REMARKS/ARGUMENTS

A new drawing page in which Fig. 7 has been amended is being submitted herewith. In particular, Fig. 7 now shows the subject matter described in claims 19 and 20, two damping chambers separated from one another by a dividing wall or partition 38 (shown in dashed lines in Fig. 7), as well as a catalytic converter 39 provided in the partition 38. Page 10 of the specification has also been correspondingly amended.

Fig. 7

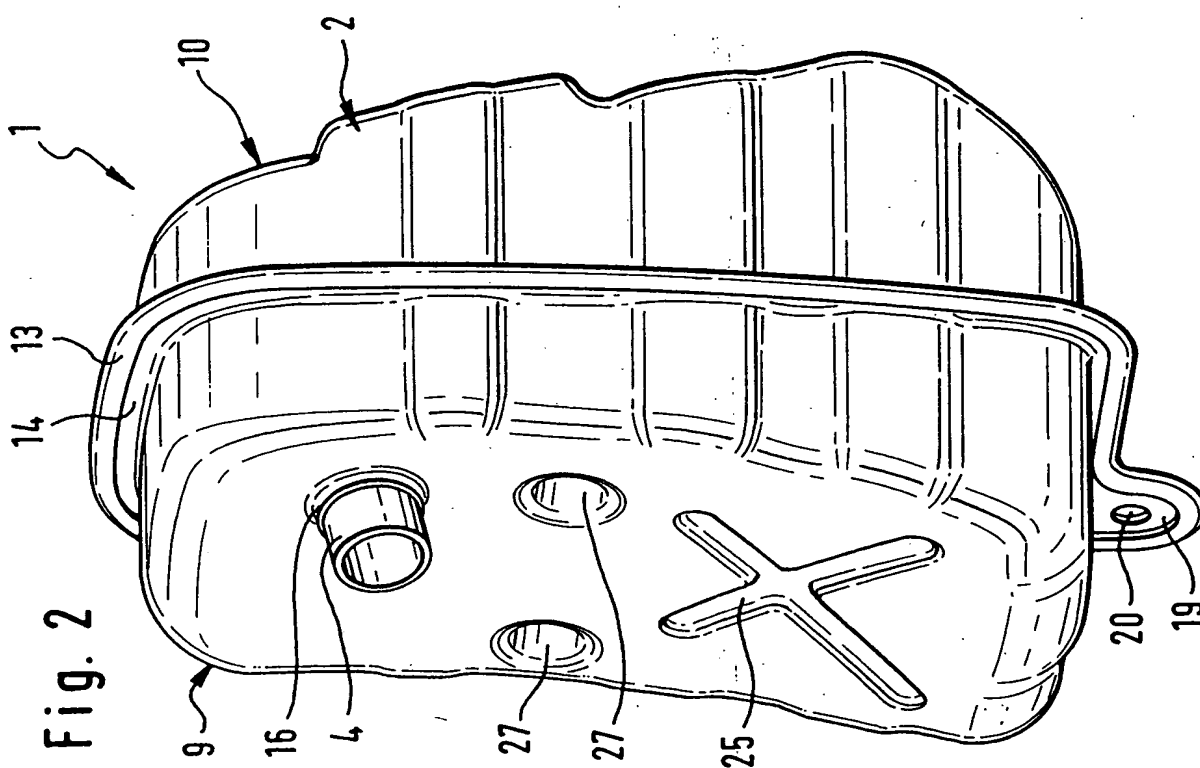
Formal drawings are submitted herewith (Figs. 1 – 11). Fig. 7 has been amended after initial preparation of the formal drawings. Fig. 7 on page 2 of the formal drawings is withdrawn and a new Fig. 7 is included herewith. Fig. 6 on page 2 of the formal drawings remains unchanged.
